Sent: 17/07/2019 2:41:49 PM
Subject: Attention Alex Keller. Modification (Mod2019.0172 – DA 2015/1258)
Attachments: AdditionalConcerns62EvansStreet_July2019.pdf;

Re. Development at 62 Evans Street Freshwater
(Mod2019.0172 – DA 2015/1258)

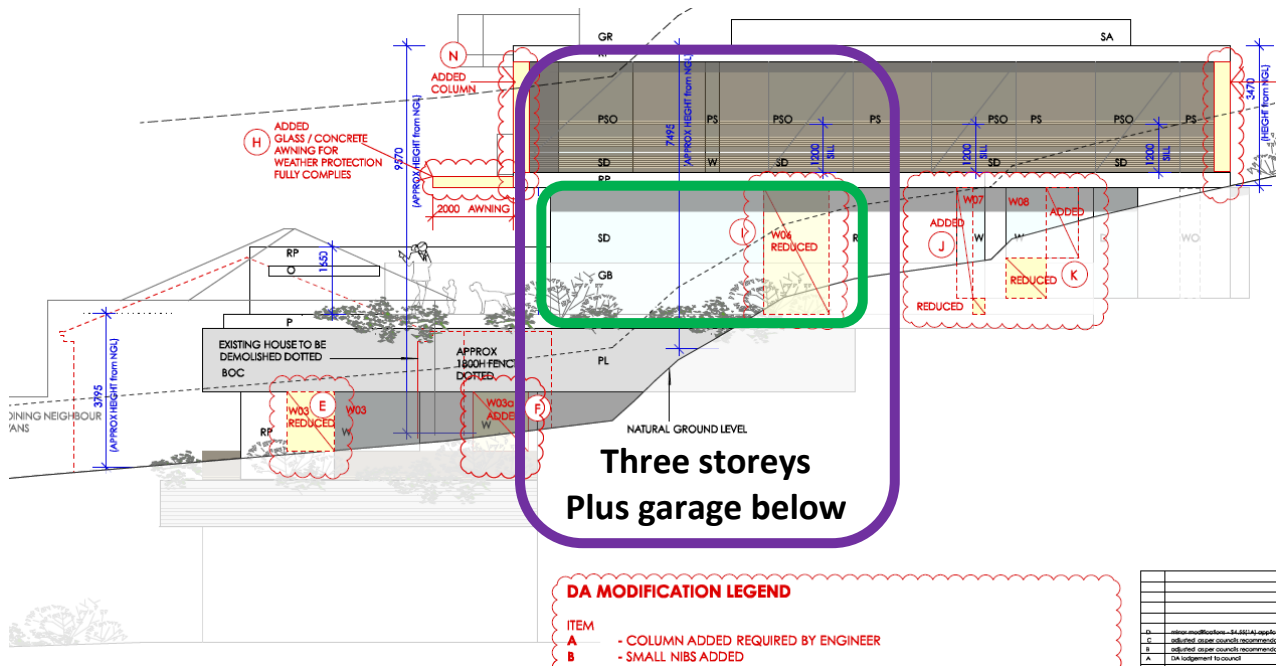
Due to the construction in its present state, the western side of our home is now continually in shade. While I understand that we are presently in the winter season, there is no sunlight in that part of our property and this lack of sunlight questions the accuracy of this statement. We have lived in this house for the last 26 years and even in the winter months, we used to have some sunlight on that part of our home. Now we have none!

proposed in the recent modification (Mod2019.0172 – DA 2015/1258) are definitely not highlight windows in the south-eastern wall of the development. On page DA09 (D) there is a sliding door as well as very large floor to ceiling window (**green rectangle**). These will allow any occupants to look directly into our kitchen, deck and yard. They can even now see straight into our bathroom. We objected to these in the original DA and have again objected to them in this most recent modification. There is also no mention of any “operable screens”, whatever they are on any of the plans. So even if these things are identified as being able to “ensure adequate privacy”, as they are not listed on the plans, there will be no requirement for them to be put in place. The upper storey has Privacy Screen opening (PSO) but there is no such requirement on the windows in this section of the building.

The elevation diagram included on page 3 above, [page DA09 (D)] (Mod2019.0172 – DA 2015/1258) identifies that there are three storeys at the middle section of the building (**purple rectangle**). However, it does not show that after the actual excavation which has been undertaken, there may be four storeys at some sections of the block. This is because of the removal of rock at the northerly end of the block where the owner insists there is only one storey and where a concrete slab was laid at the same level as the slab for the garage.
